MBUX multimedia system: The central display is dark, various other system complaints

Topic number	LI82.85-P-071623
Version	4
Function group	82.85 - Navigation and Communication systems
Date	2/24/22
Validity	Model series 167 with code 548/549
Reason for change	Remedy updated

Attachments	
File	Description
air vent cover A1676831400.jpg 	Optimized air vent cover

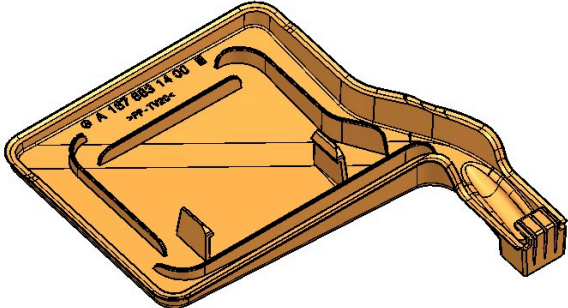
Water ingress through the air vent under the front passenger seat (see attached, note that the vents are facing the rear

of the vehicle). As a result, the head unit (A26/17) may become damaged.

Avoid using rubber floor mats for the second row seats on which water can collect and subsequently enter the air vent under the front passenger seat.

An optimized cover is now available for the air vent under the front passenger seat (see parts note). To avoid a recurrence of water damage, install this cover.
